Turkey Point

expansion project

Sufficiency Responses

Date: February 27, 2004
Project No.: 0337600-0105

Figure 2FDEP-6b
Typical Lateral Cross-Section of the L-31E, Interceptor Ditch, and Westernmost Cooling Canal

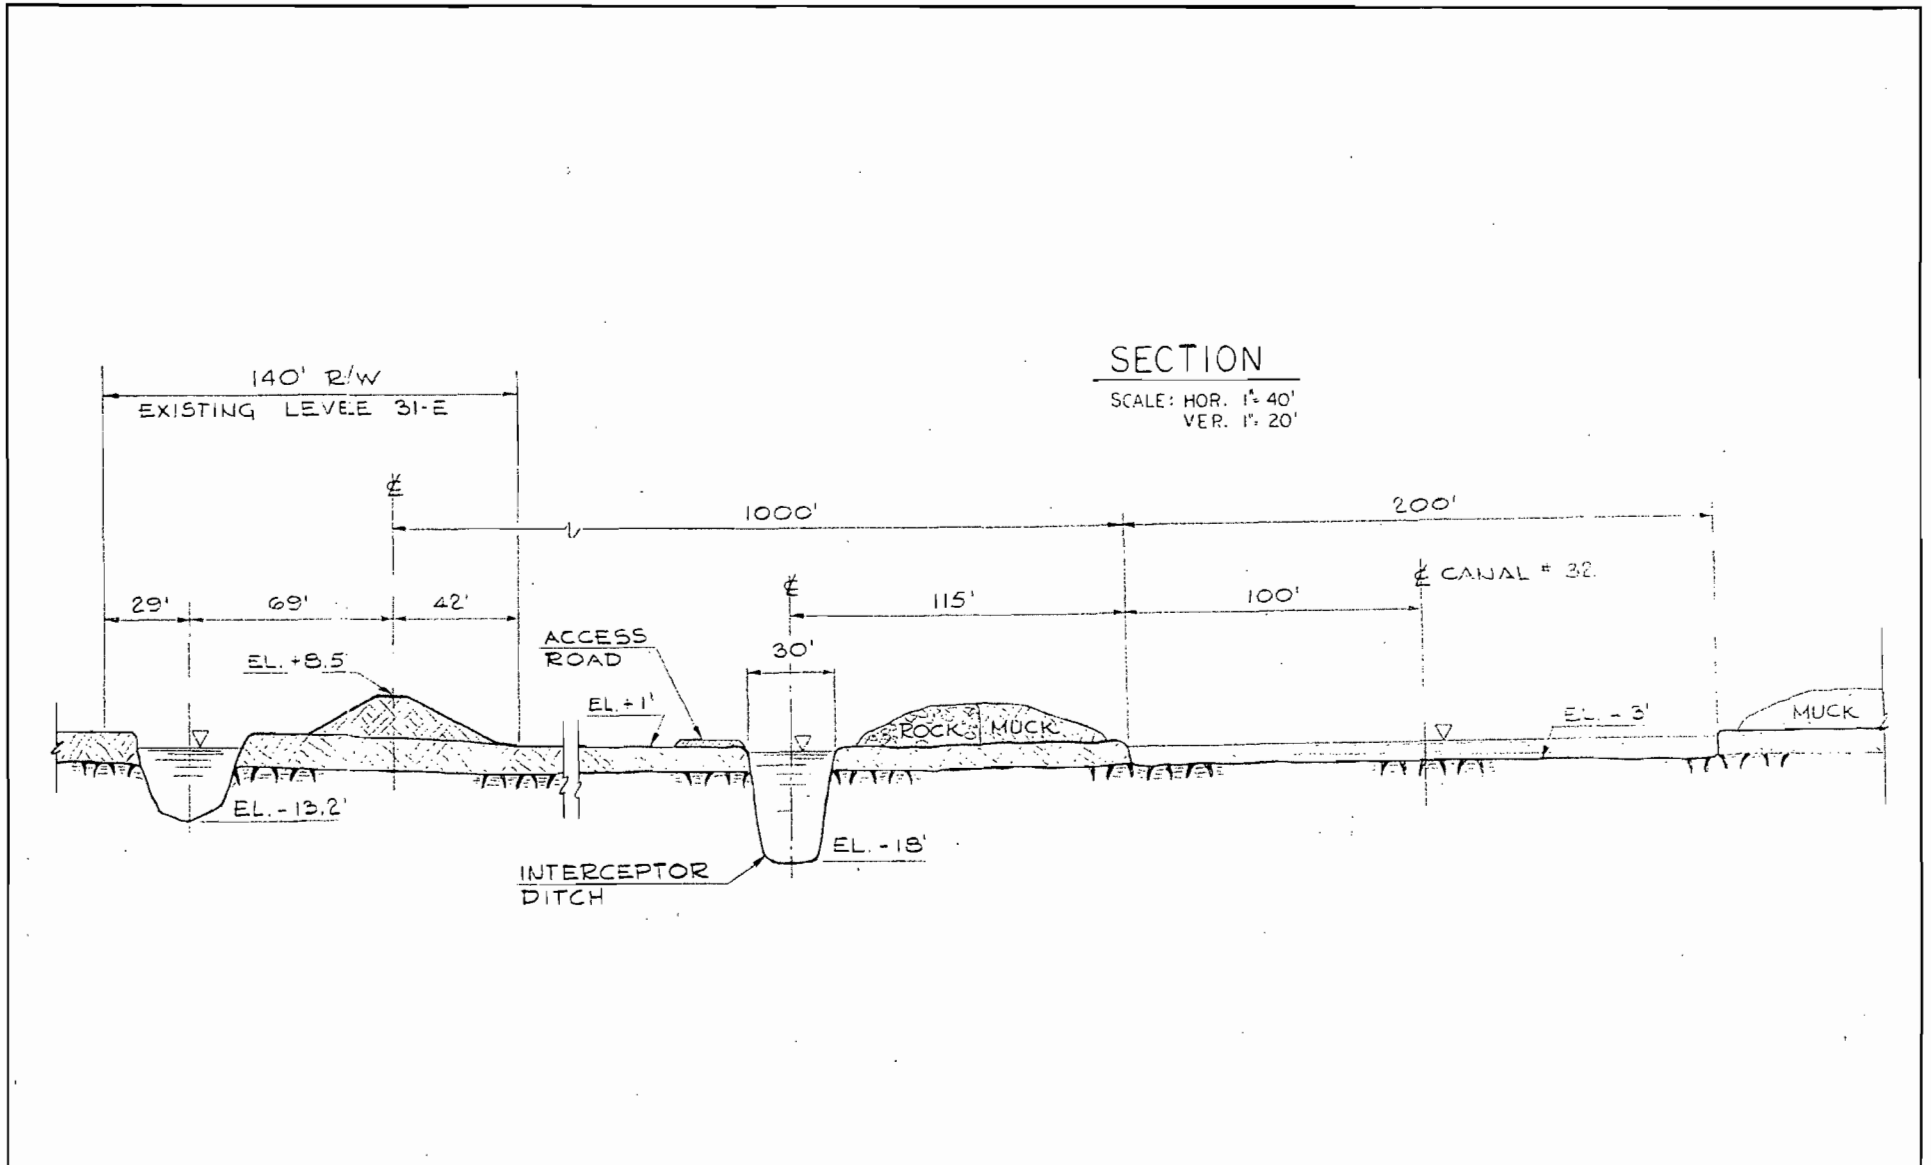
6. The report should provide further detailed discussion on the potential adverse impact from outward migration of pollutants in the proposed discharges, to the water quality in both the groundwater outside the permitted zone of discharge, and the Biscayne Bay. For groundwater movement, the existing interceptor ditch may have certain benefits as a salinity barrier, but its effectiveness in prevention of general pollutants migrating in the deeper zone (beneath the trench bottom) needs to be further demonstrated. (Please include in the discussion a typical lateral cross section profile for the cooling canals and the interceptor ditch.) 2FDEP-6

Since the cooling canal system operates at about 1.6 times the salinity level of Biscayne Bay (refer to updated Appendix 10.7 in Replacement Pages), any leakage of cooling canal water west of the interceptor ditch would show up as an increase in salinity. Since no such increase has been observed, it is concluded no such leakage is occurring. Figure 2FDEP-6b is a typical lateral cross-section of the L-31E canal, interceptor ditch, and westernmost cooling canal. Additional cross-sections of the cooling canal system are presented in the updated Appendix 10.7 (see response to 2FDEP-4 above).

Figure 2FDEP-7(a)-1
Biscayne Bay Aquatic Preserve

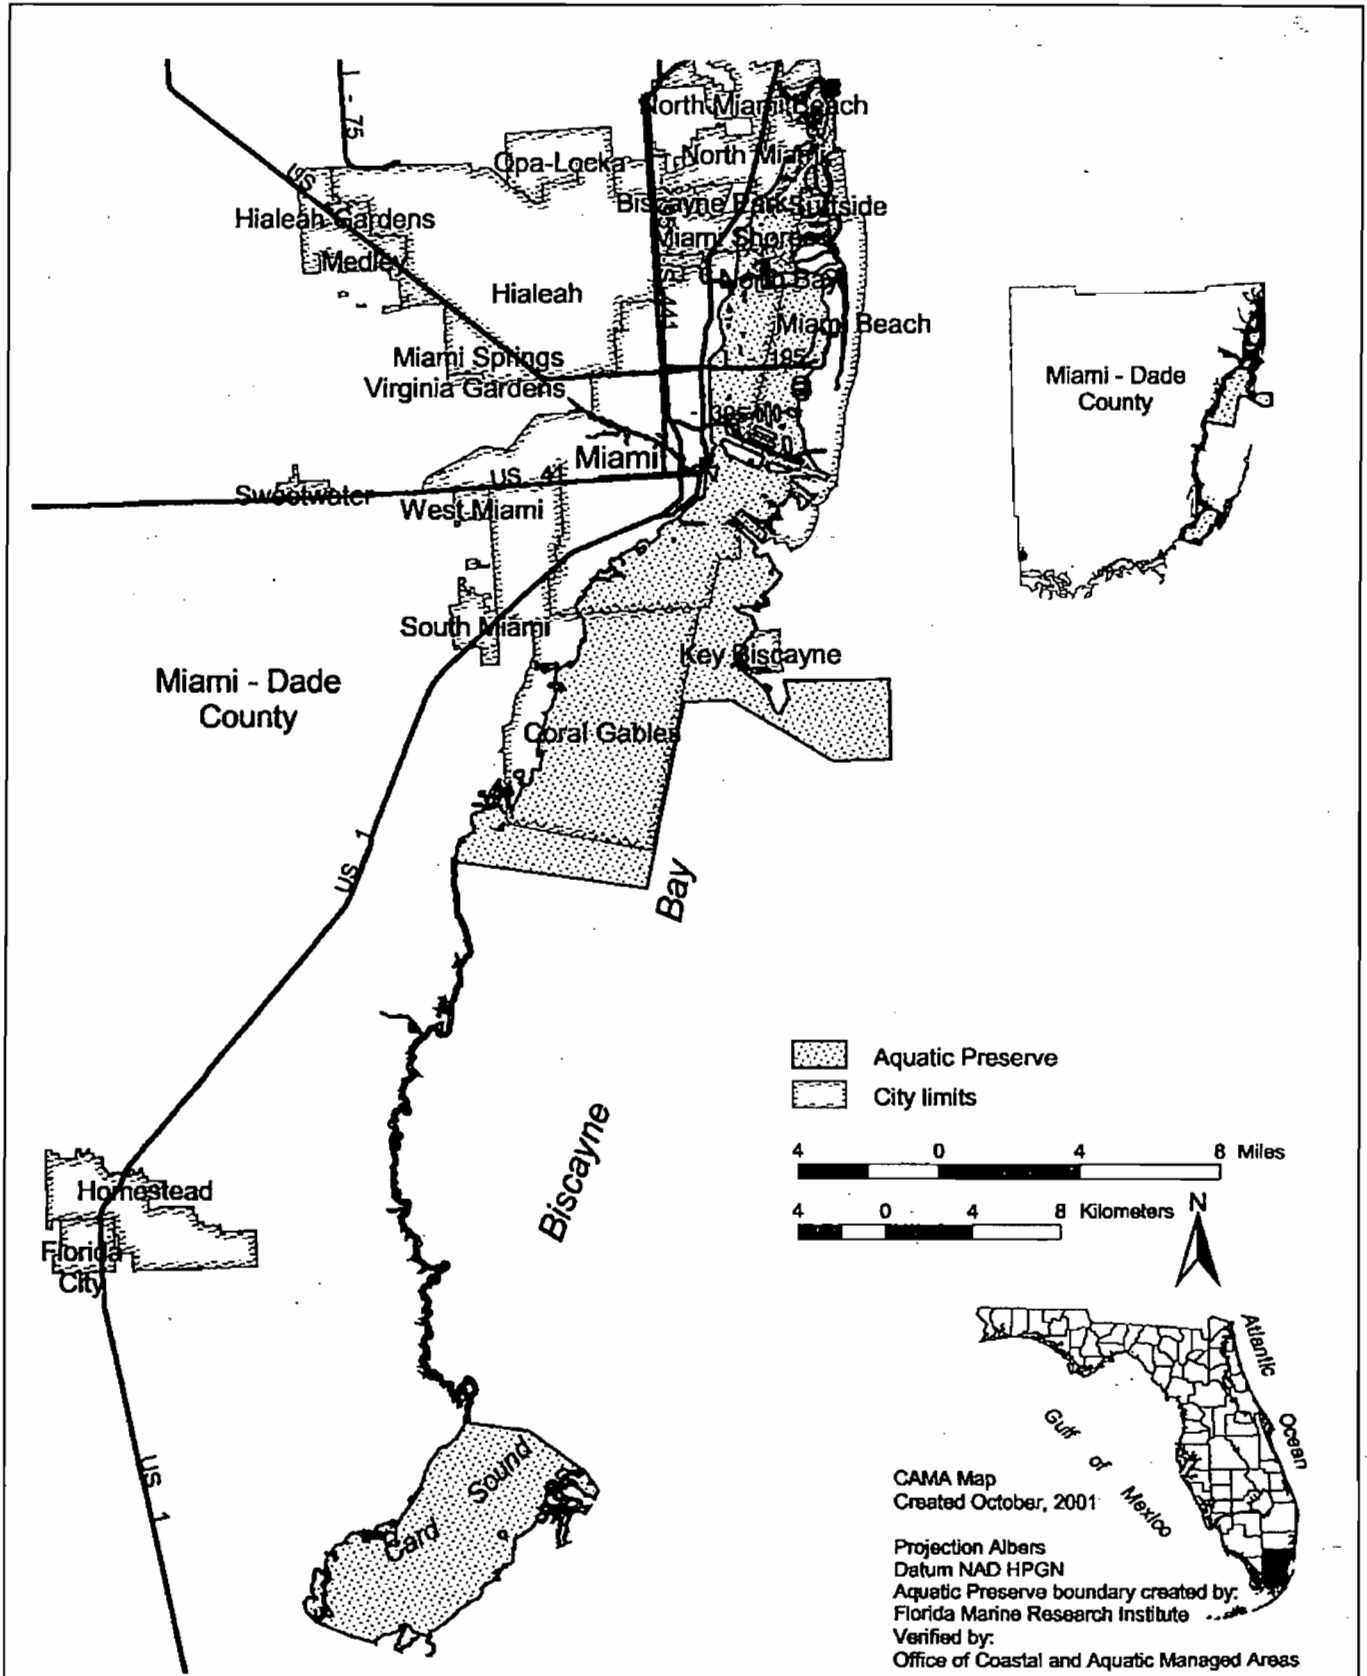
2FDEP Comment 7(a): A remark on page 2-7 states “only a small portion of the 5-mile study area contains a portion of the aquatic preserve.” Using Figure 2.2-1 as a reference, it would appear the entire ocean side of the study area falls within the Biscayne Bay Aquatic Preserve Area, and also within the Biscayne Bay SWIM Planning Area.

Response 7(a): The statement on Page 2-7 is correct in that only a small portion of the Biscayne Bay aquatic Preserve is located within 5 miles of the Project Area. Most of the area of Biscayne Bay near the Turkey Point Plant is within the Biscayne Bay National Park. The areas designated as the Biscayne Bay Aquatic Preserve and the Biscayne Bay National Park are shown in Figures 2FDEP-7(a)-1 and 2FDEP-7(a)-2, respectively. The commenter is correct that the Biscayne Bay SWIM Planning Area encompasses the entire portion of Biscayne Bay within 5 miles of the Project Area.

Figure 3.5-1.
Average Water Use Diagram

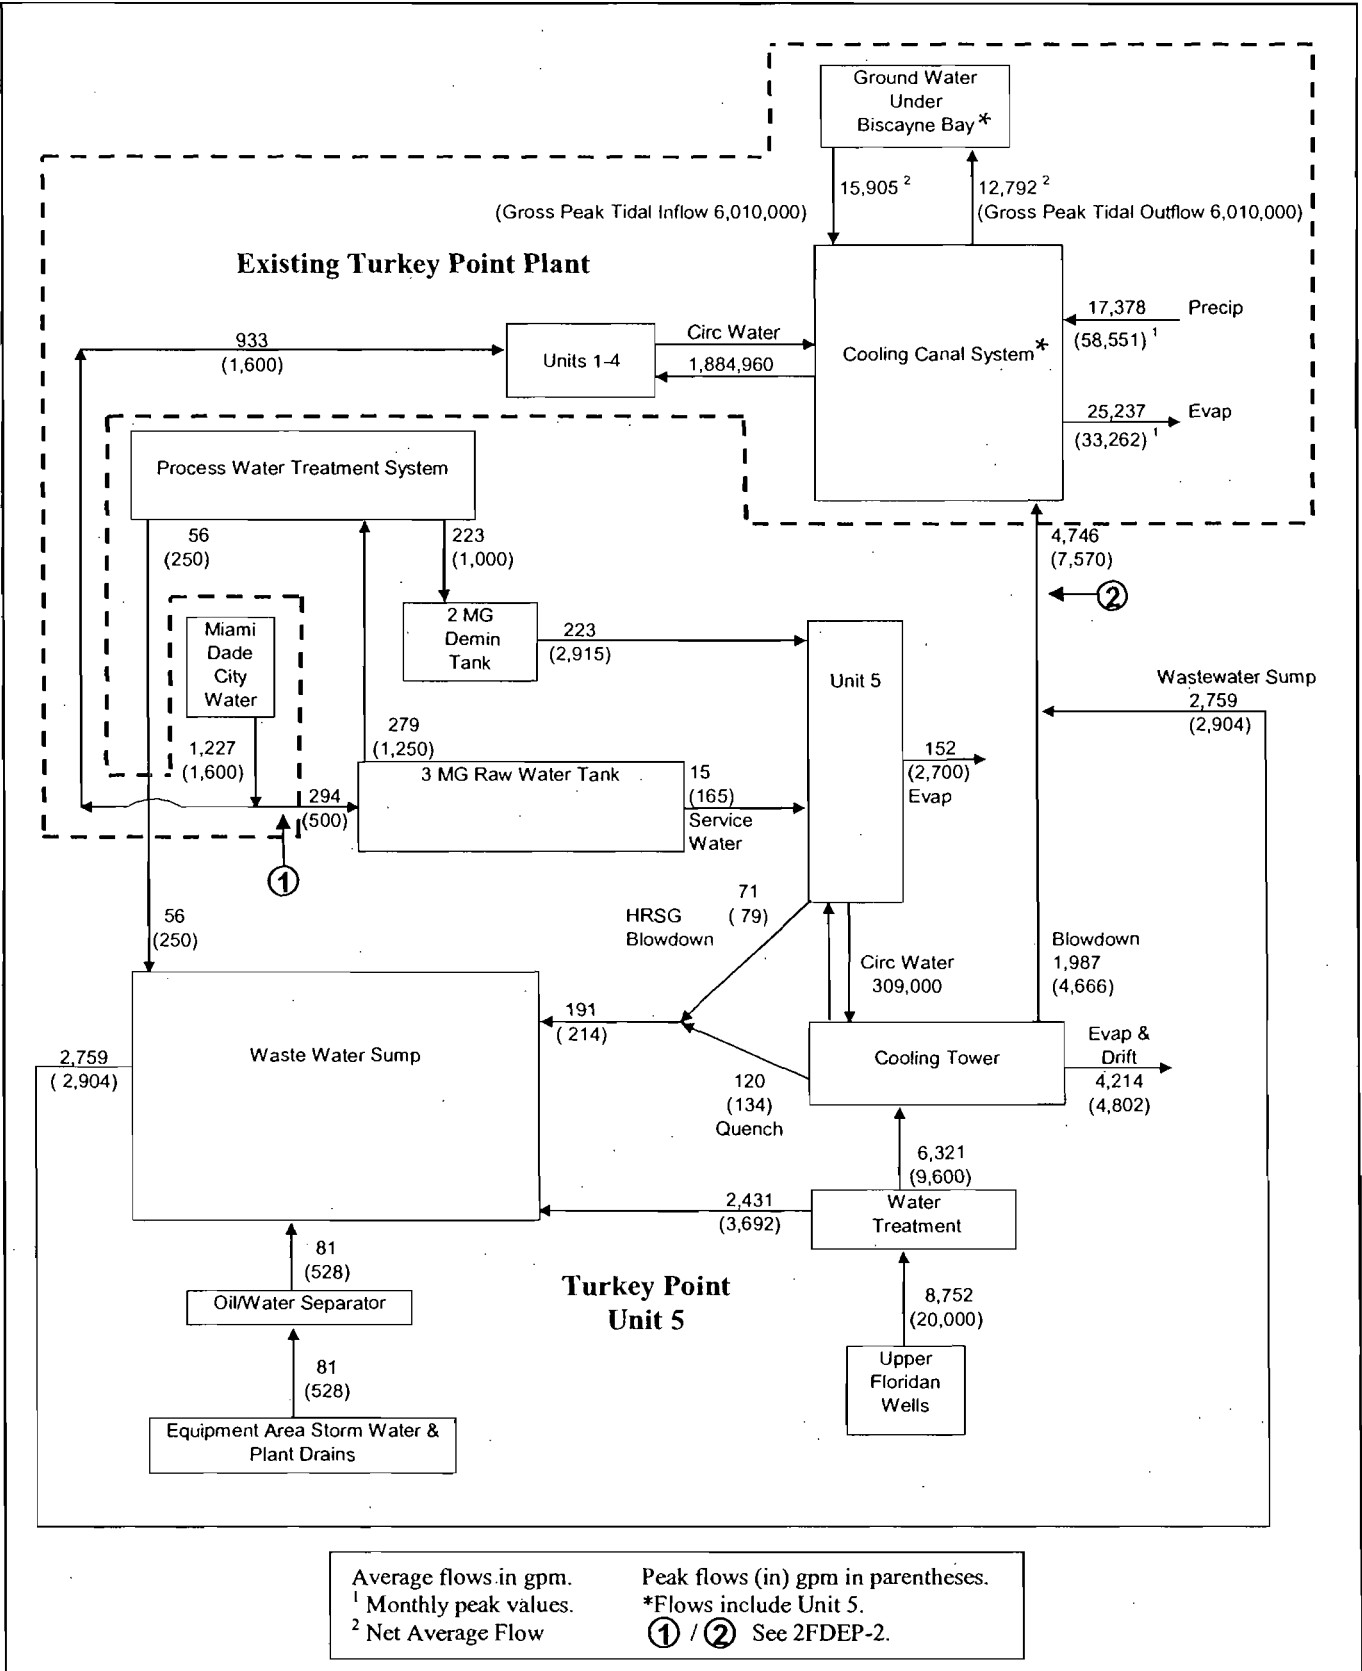
2FDEP Comment 2: Please expand and revise the flow schematic as presented in Figures 3.5-1 and 3.5-2, to distinct the process "waste water sump" into its existing individual components of neutralization basin B-1, and solids settling basins B-2 and B-3, and any other new treatment components being proposed under the expansion. (Attached here for sample is a file copy of the flow diagram for March 1, 1993, showing more details for the flow schemes.)

Response 2: Figures 3.5-1 and 3.5-2 have been updated and are attached as replacement pages. These figures were revised to identify the existing and new facilities and were updated to reflect the updated Cooling Pond Modeling Report contained in the SCA as Appendix 10.7 (see response to 2FDEP-4). Figure 2FDEP-2 identifies the connections on the previous waste flow diagram. The waste water sump shown on Figures 3.5-1 and 3.5-2 is a new facility that will serve Unit 5 only. The sump location is shown on Figure 3.2-2 as Item 16, designated "stormwater sump". Neutralization Basin B-1 and solids settling basins B-2 and B-3 serve existing Units 1-4 exclusively and are already permitted.

Figure 3.5-2.
Special Water Use Diagram

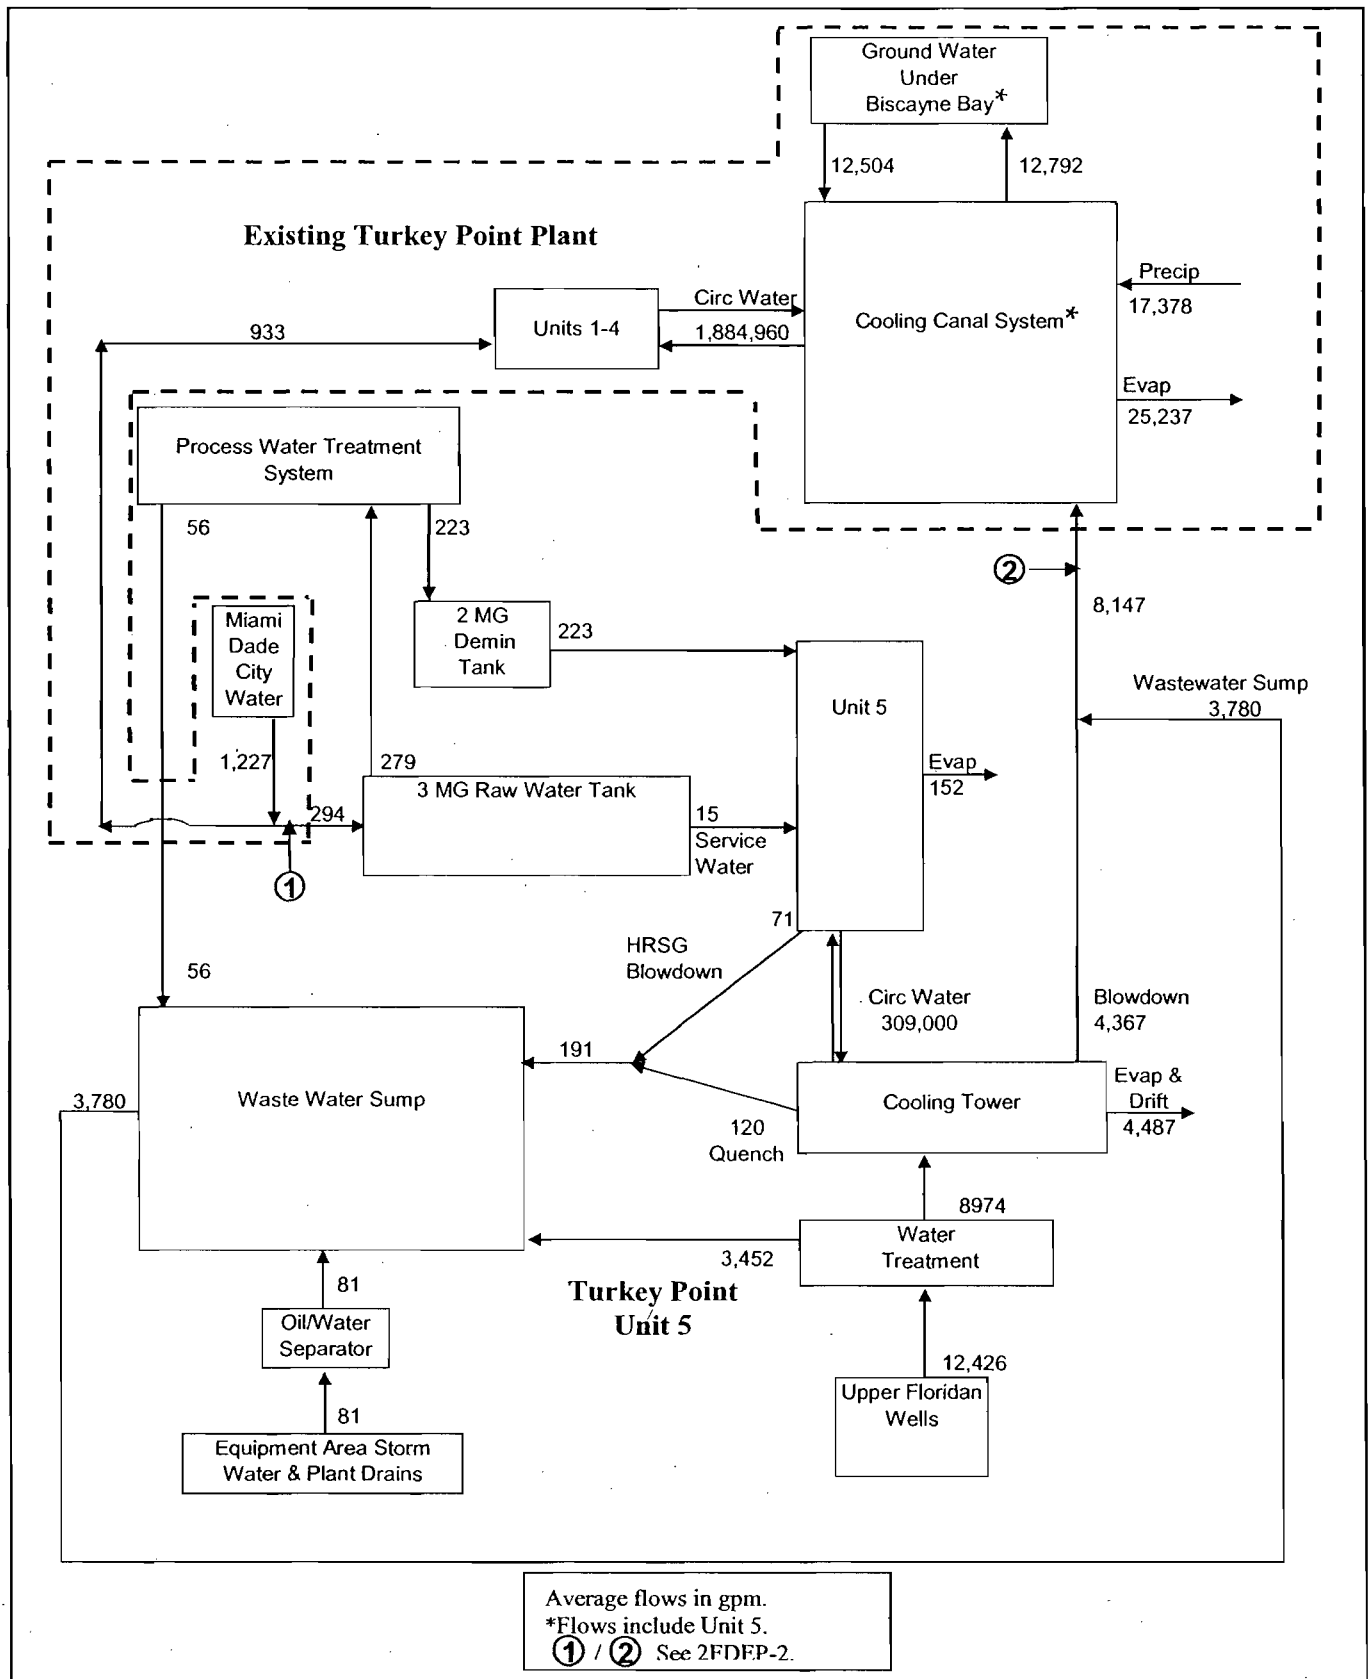
2FDEP Comment 4: Please reconcile the discrepancies in flow figures for the expansion among those presented in Figure 3.5-2 in Volume 1, and Figure 15 included in Appendix 10.7 "Cooling Pond Modeling Report" in Volume 3. It appears the latter might not have accounted for the R.O. concentrate and other process wastewater discharges involved.

Response 4: Appendix 10.7 has been updated to include all wastewater releases to the cooling canal system. The updated SCA Appendix 10.7 is attached as a replacement. The water use diagrams included in the SCA, which are Figures 2.3-8, 3.5-1, and 3.5-2, have also been updated and are attached as replacement pages. The R.O. waste stream of 56 GPM is accounted for with the other waste streams. The total waste stream is 4,746 GPM, while the R.O. waste stream is 1.2 percent of the total waste stream. Water from the Miami-Dade public water supply will be used as the water source for the demineralization process.
